Addendum Number: 01

Addendum Issue Date: April 17, 2025

Project Name: Robinson Washington Elementary
Renovation & Addition

Project Number: 02401781.001

1 OVERALL PLAYGROUND LAYOUT PLAN
SCALE: 1" = 40'

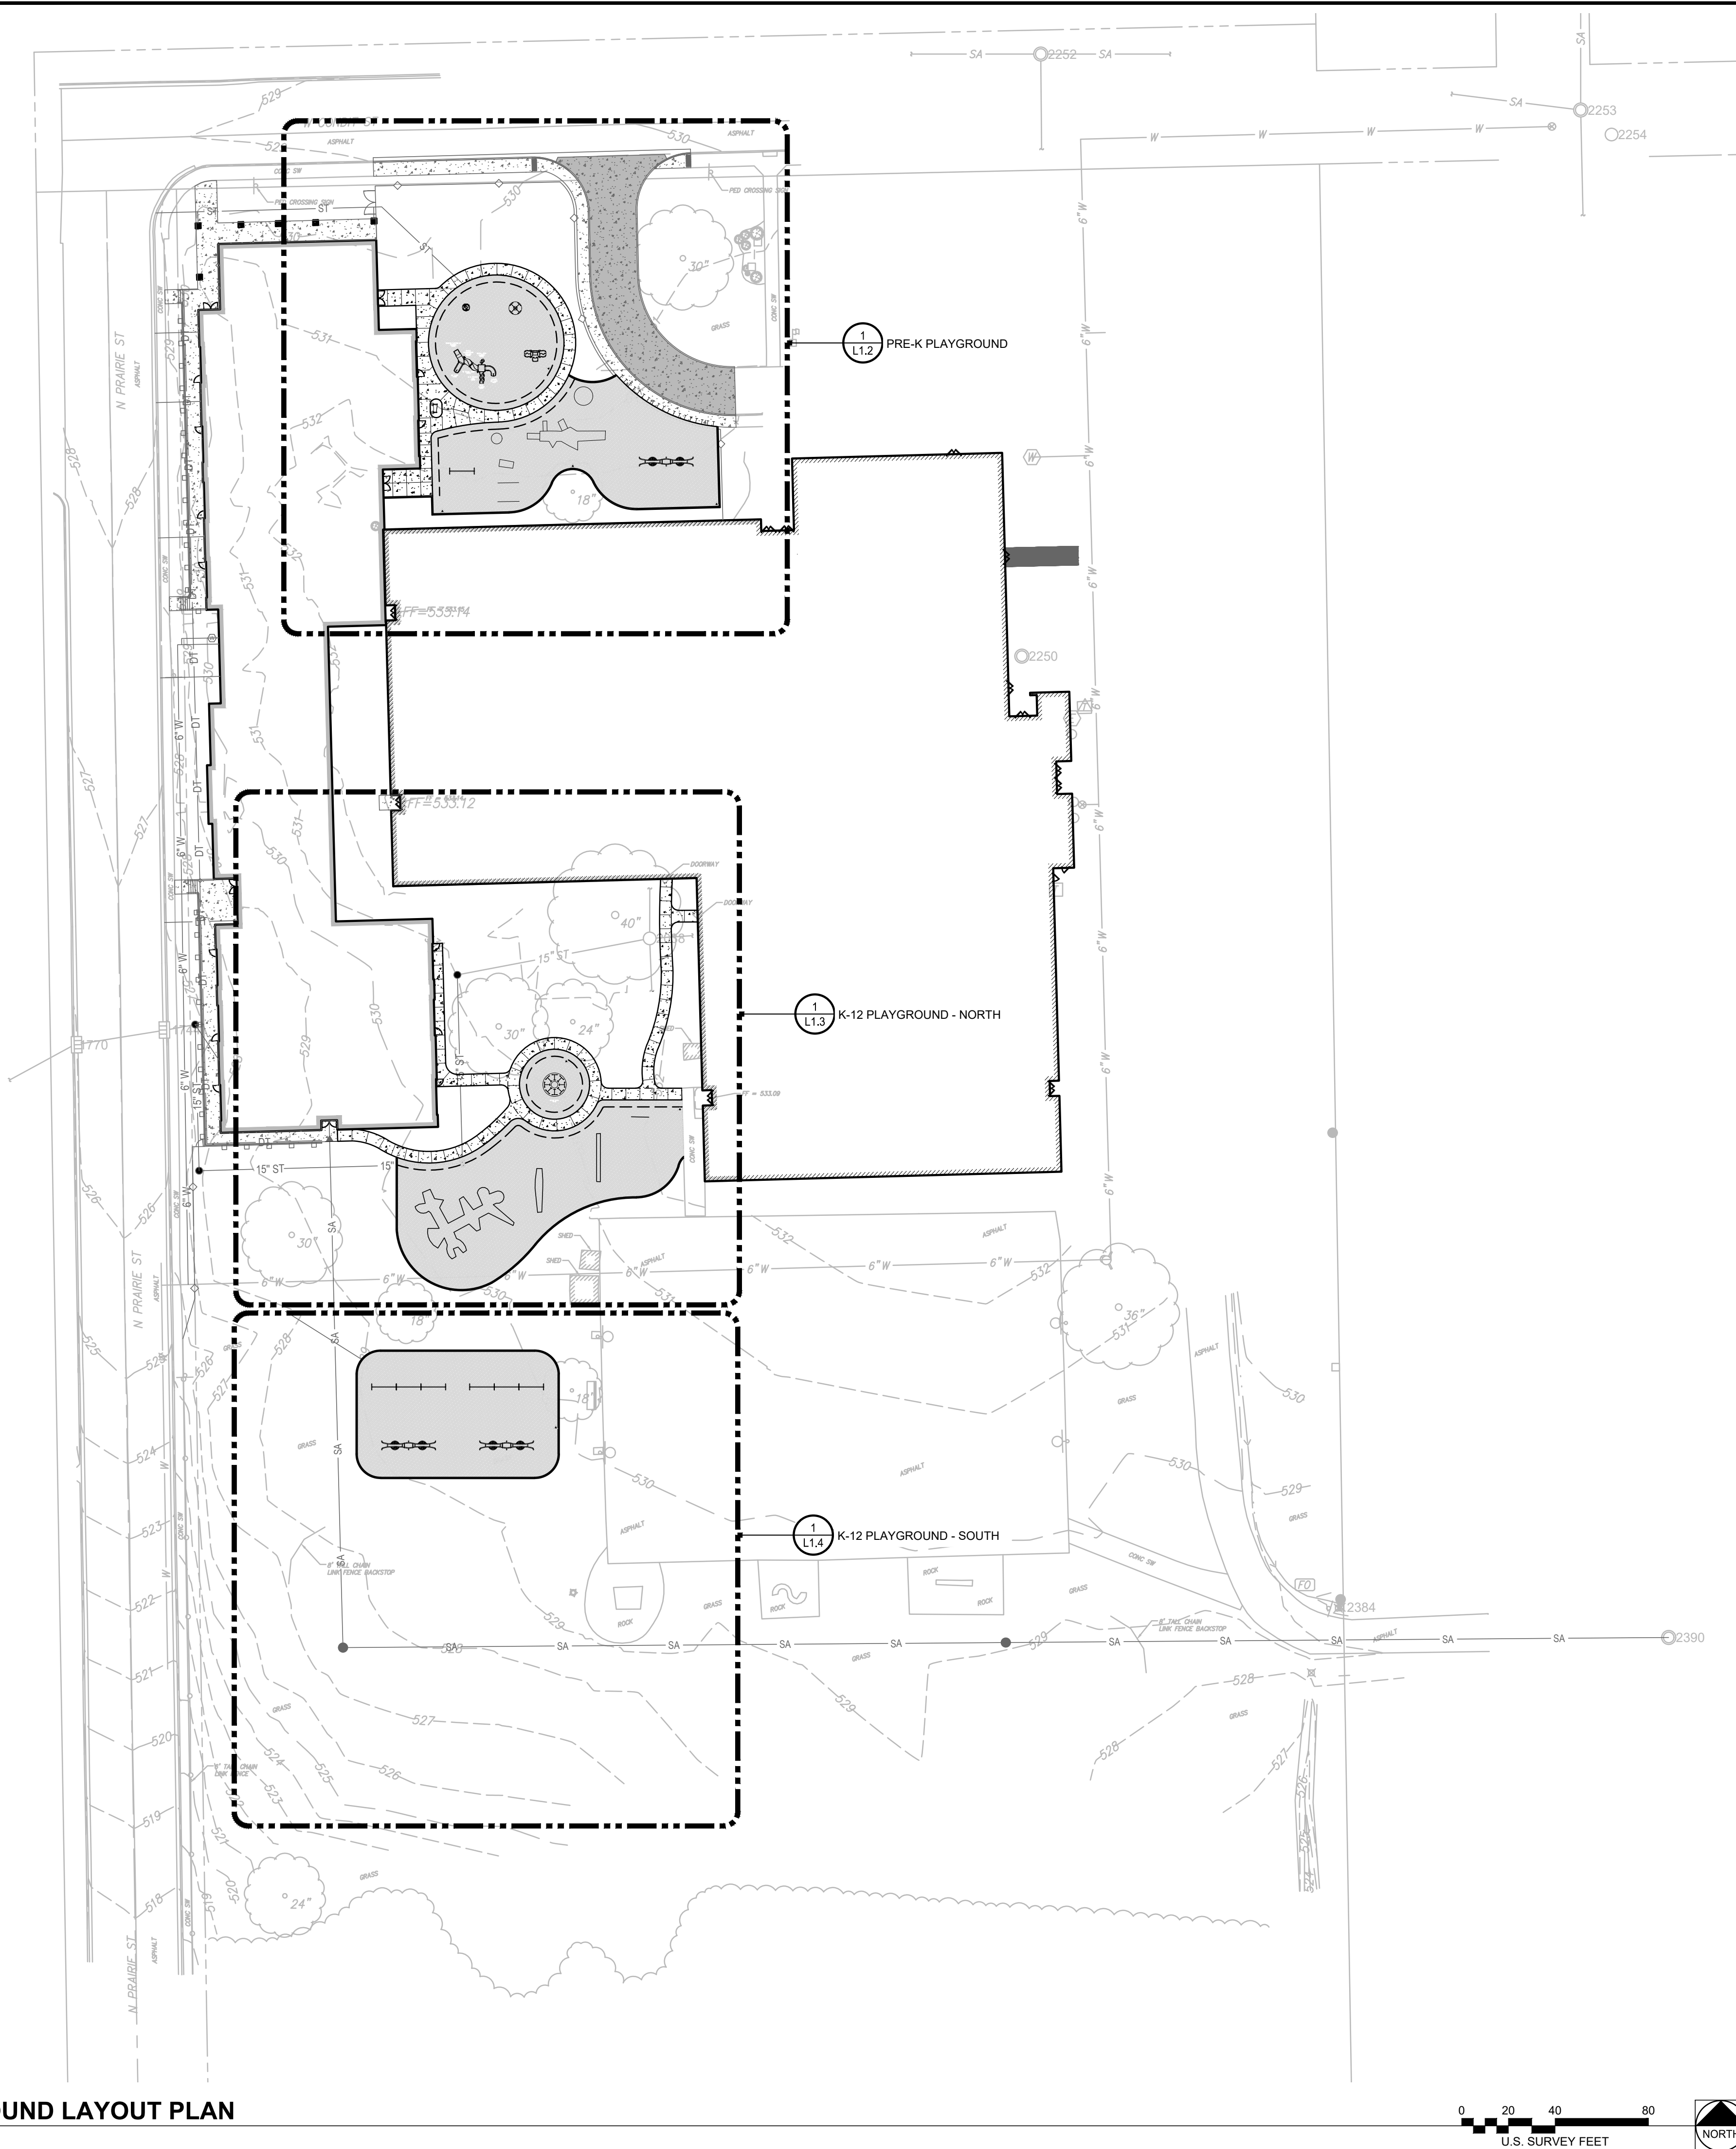
- a. REVISE Existing Playground Equipment Notes #4.2 to clarify that refurbishing of existing playground equipment is the Owner's responsibility.

OVERALL FLOOR PLAN

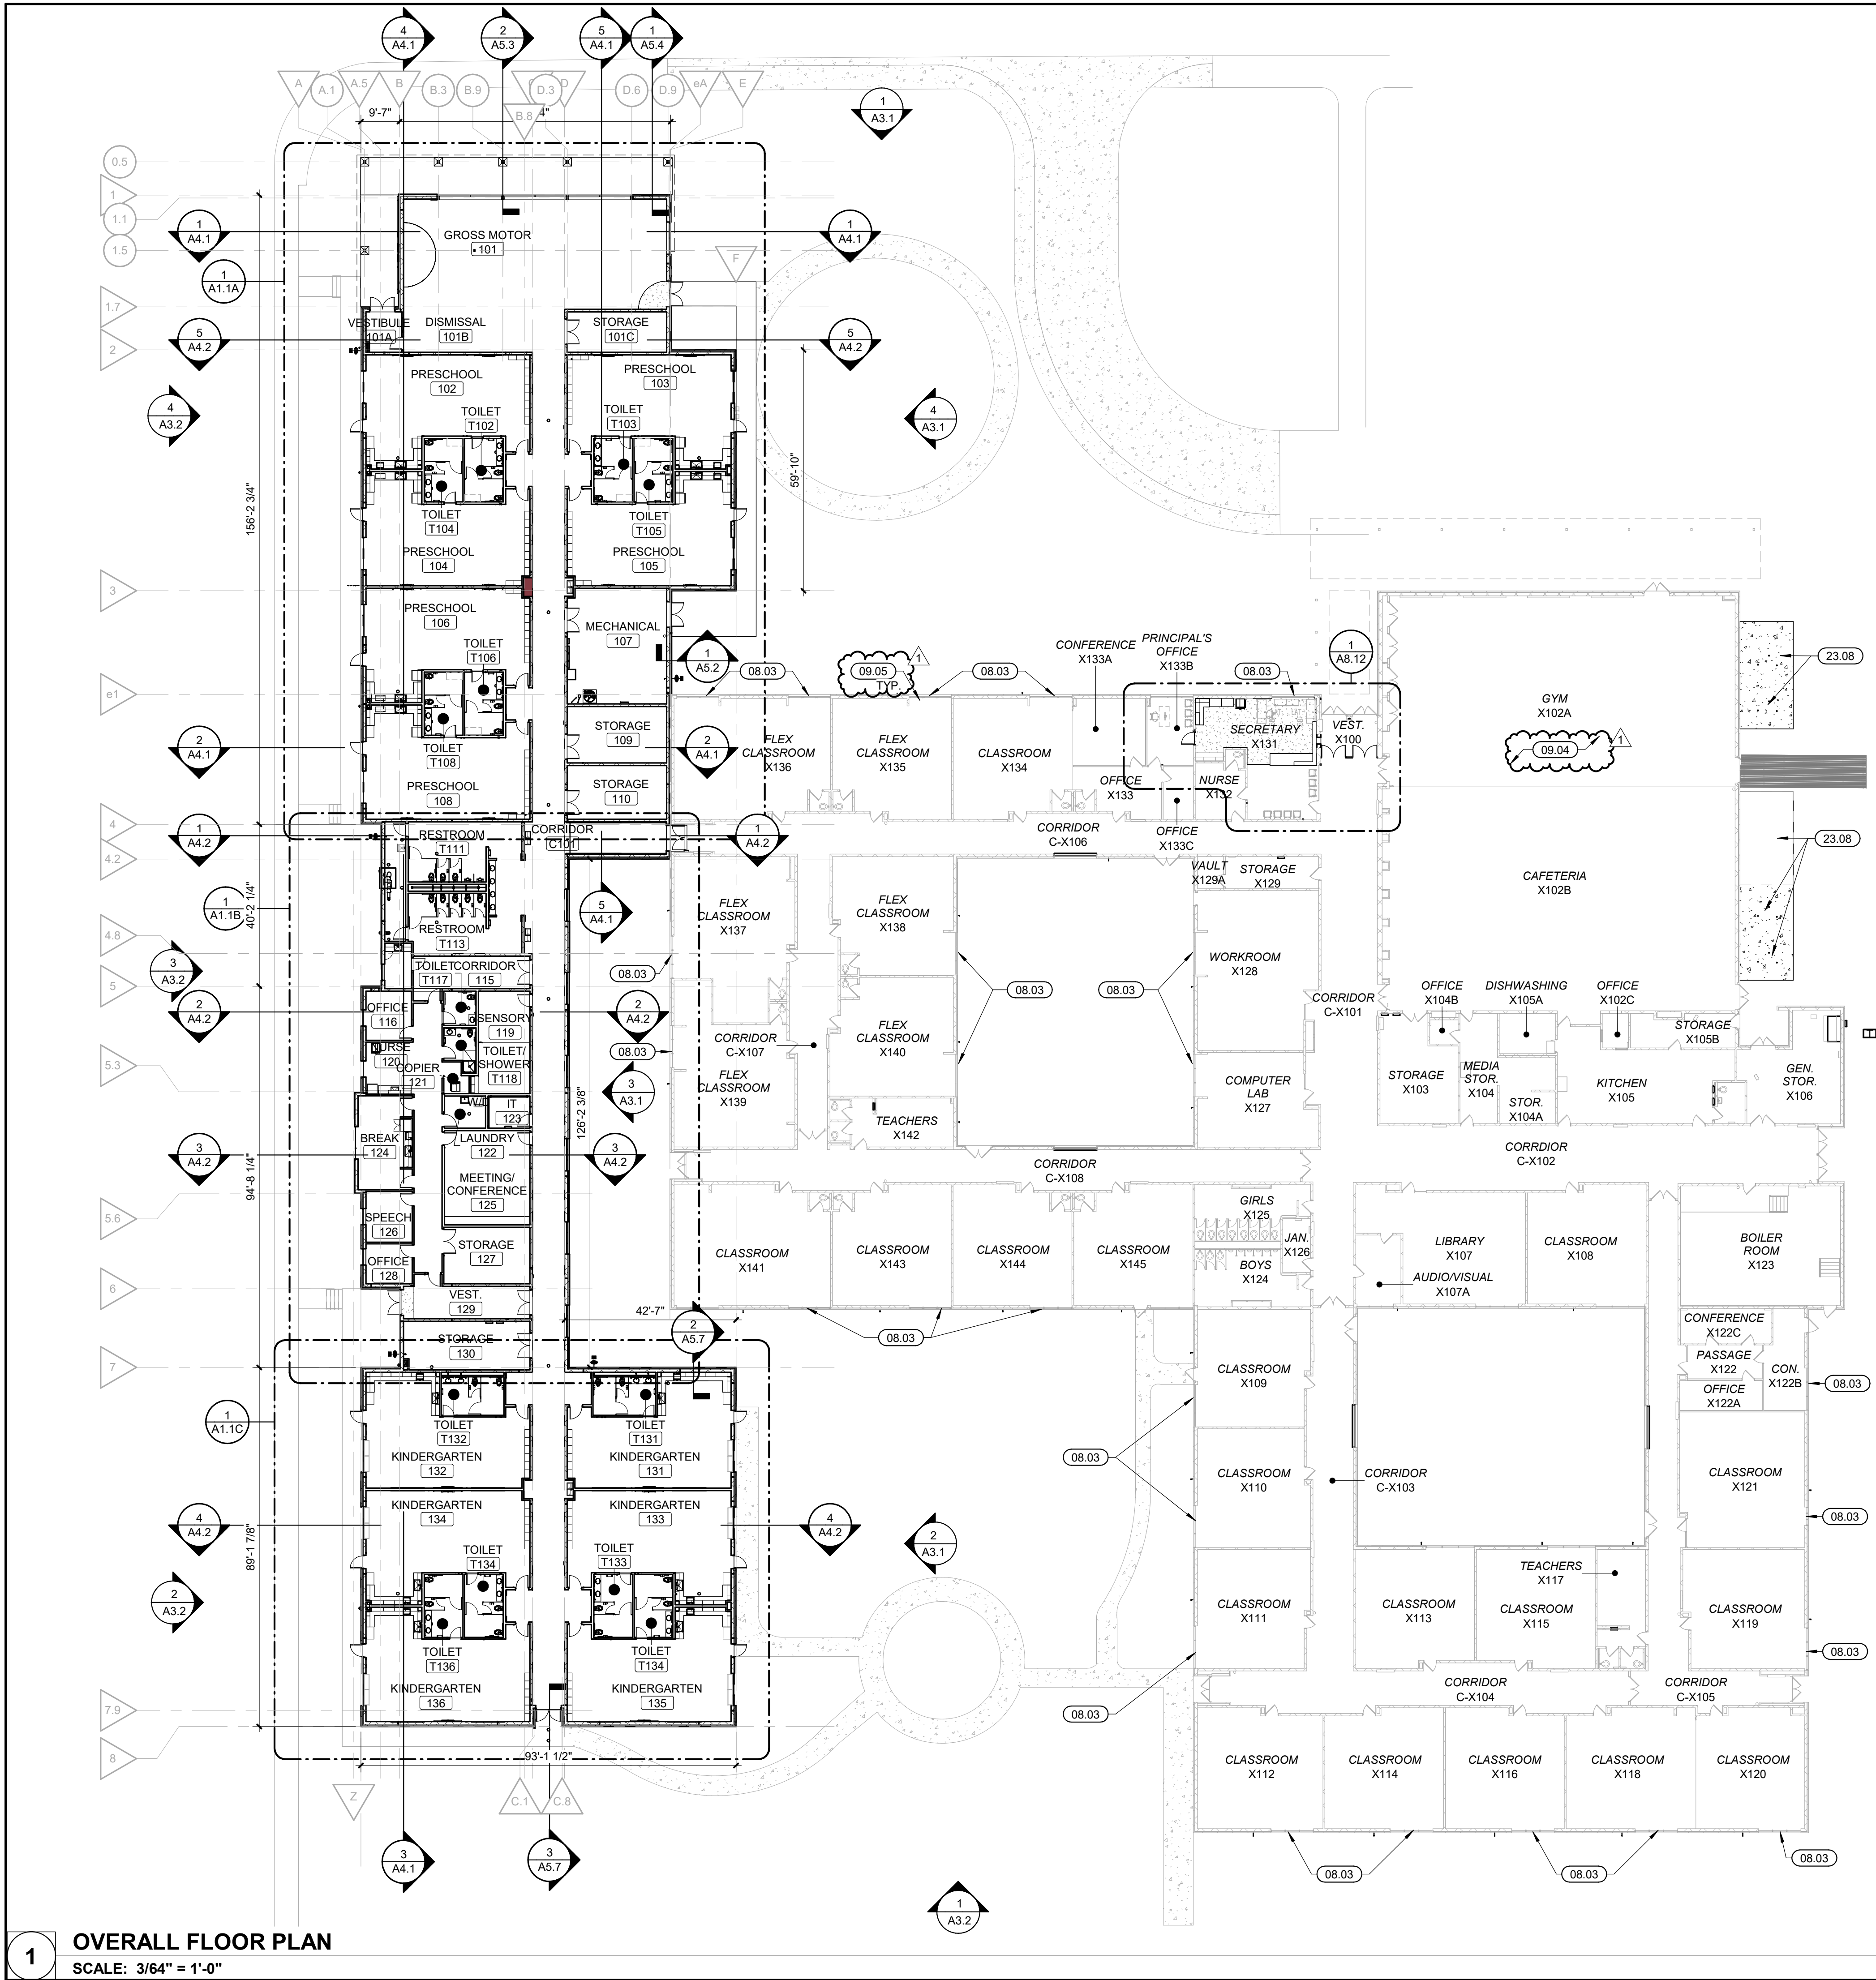
- a. ADD general note L to read, "ALL EXISTING FINISHES SHALL REMAIN UNLESS OTHERWISE NOTED. PATCH AND PAINT, INSTALL ADDITIONAL CEILING GRIDS OR TILES, ETC. AS REQUIRED IN ORDER TO PERFORM NECESSARY MECHANICAL INSTALLATION." See attached.
- b. ADD keynote 09.04 to read, "ENSURE EXISTING GYM FLOOR IS PROTECTED DURING MECHANICAL WORK." See attached.
- c. ADD keynote 09.05 to read, "INSTALL LVT FLOORING IN EXISTING CLASSROOMS WHERE EXISTING UNIT HEATER IS REMOVED. LVT FLOORING TO MATCH EXISTING." See attached.

ENLARGED FLOOR PLAN - AREA A

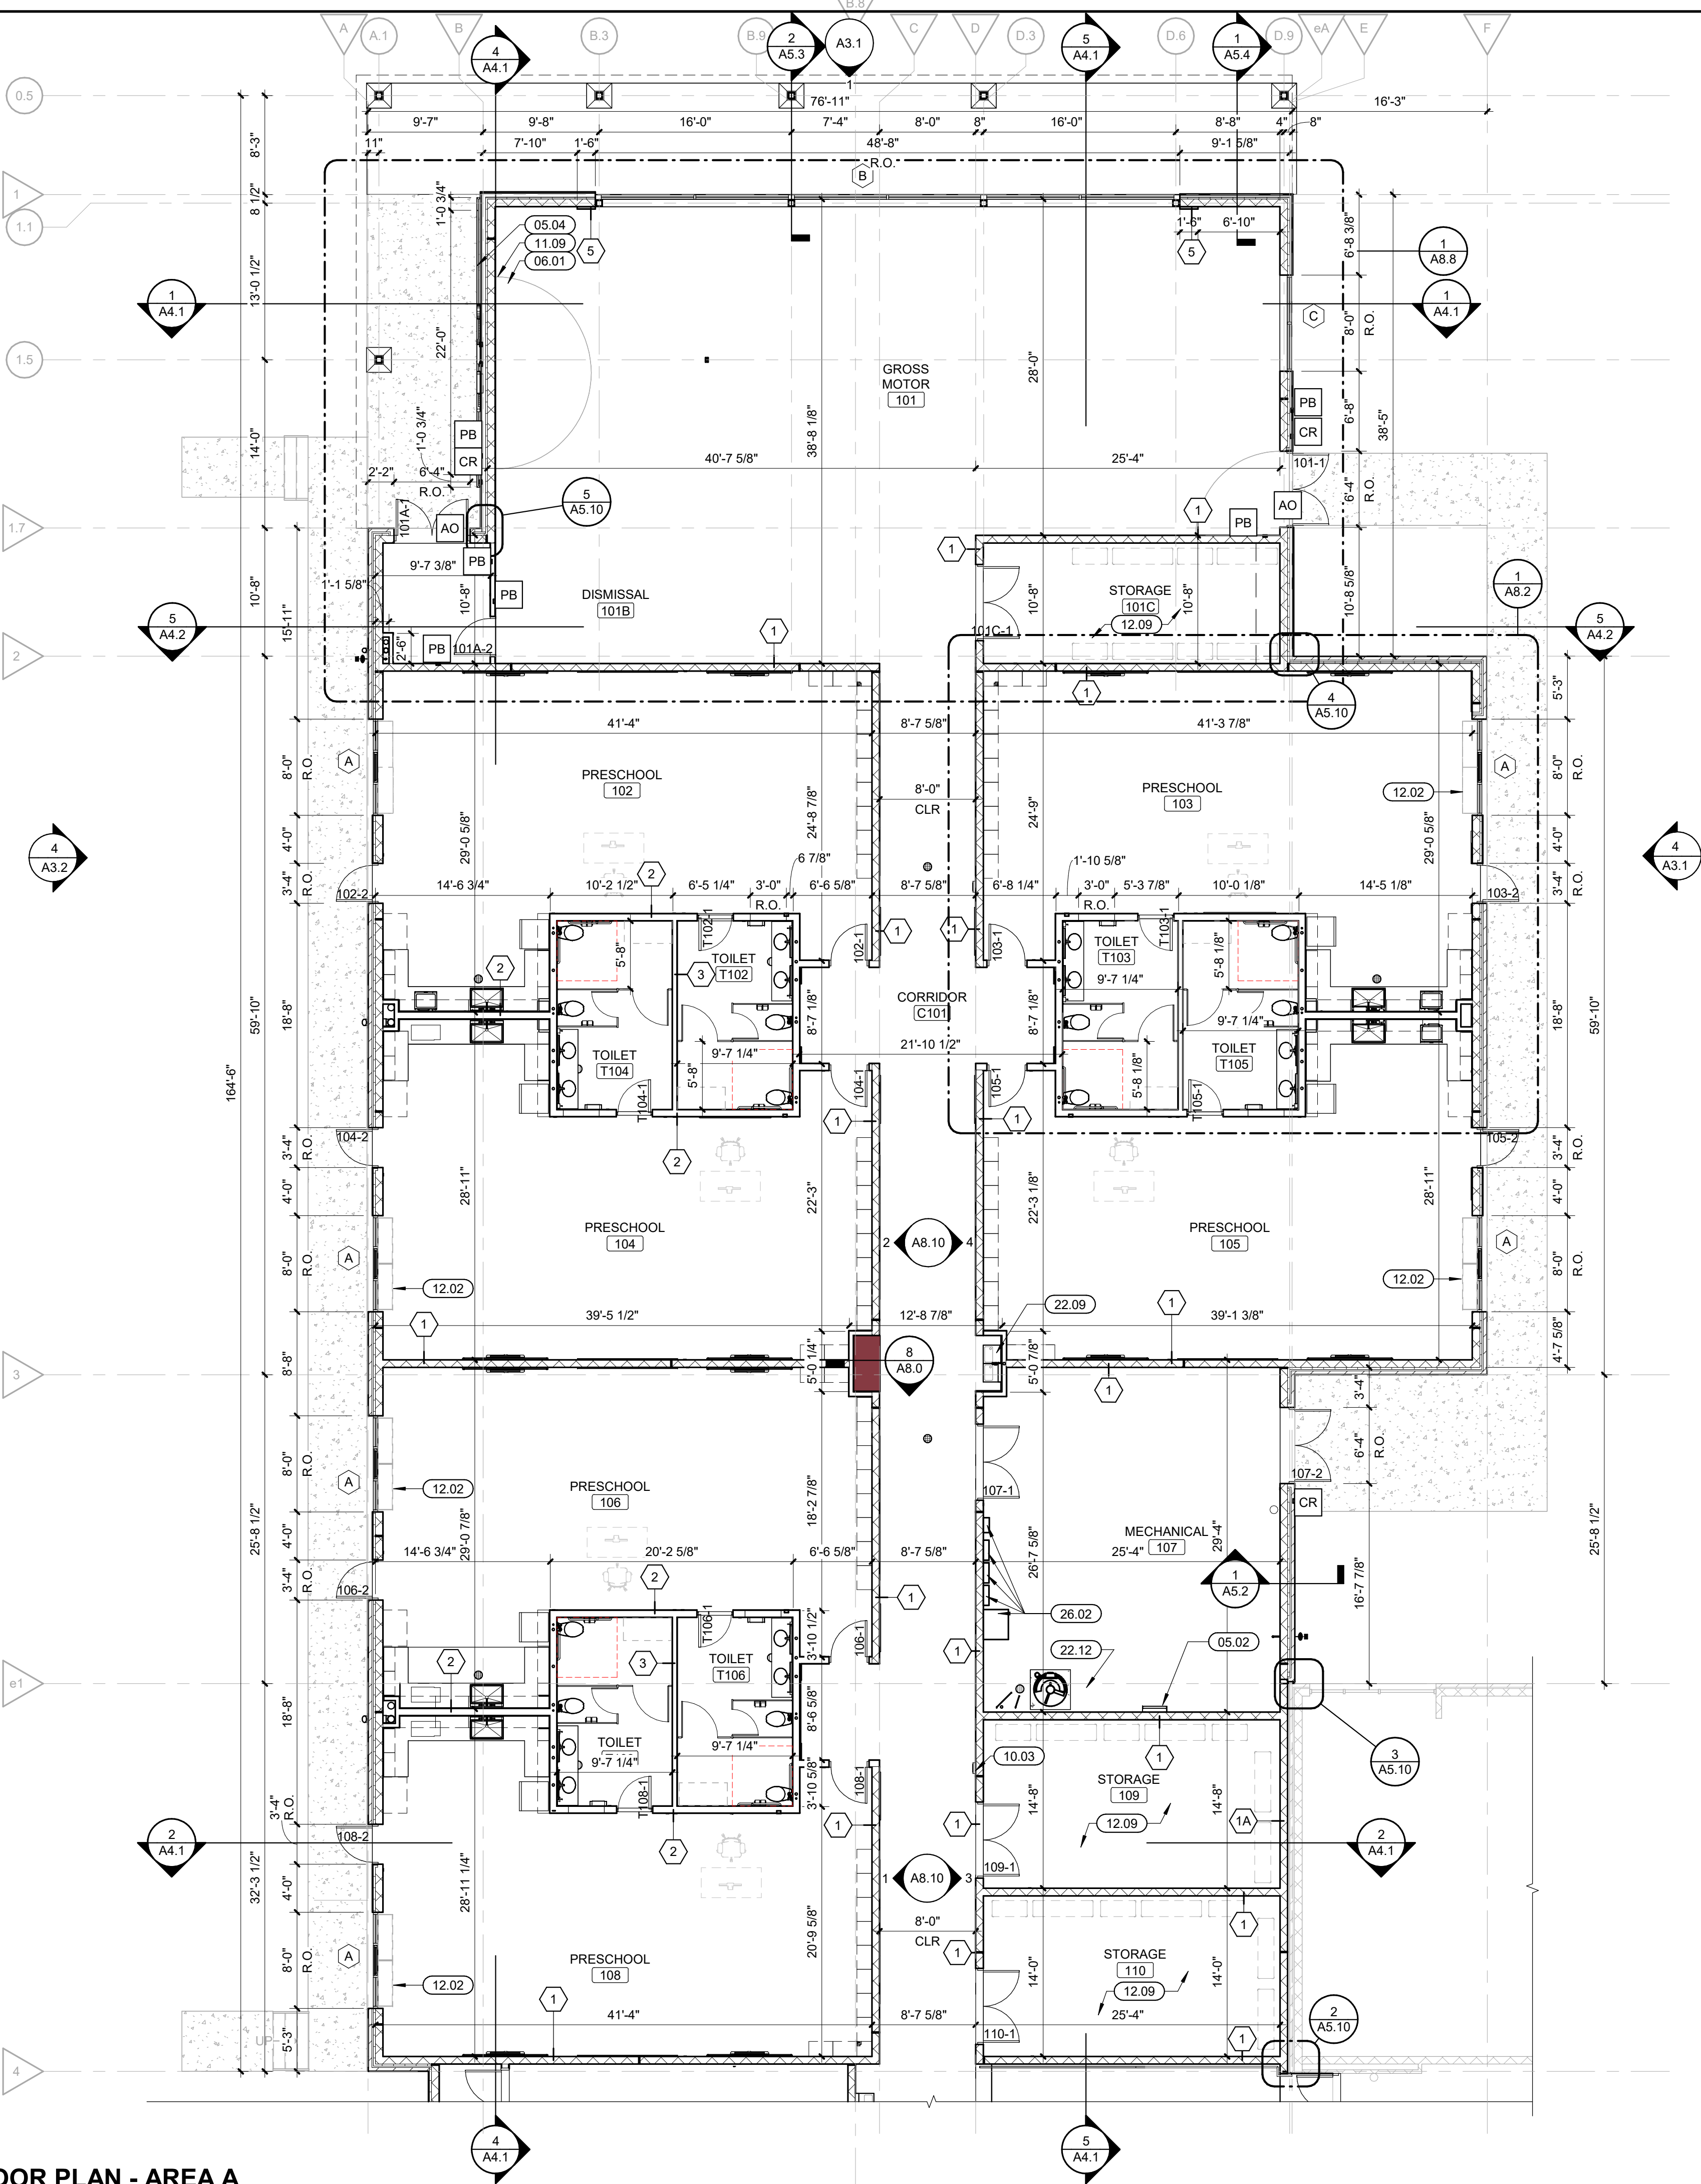
- a. REVISE keynote 05.02 to read, "EXTERIOR PRIMED 2'-0" STEEL ROOF ACCESS LADDER, PAINT." See attached.
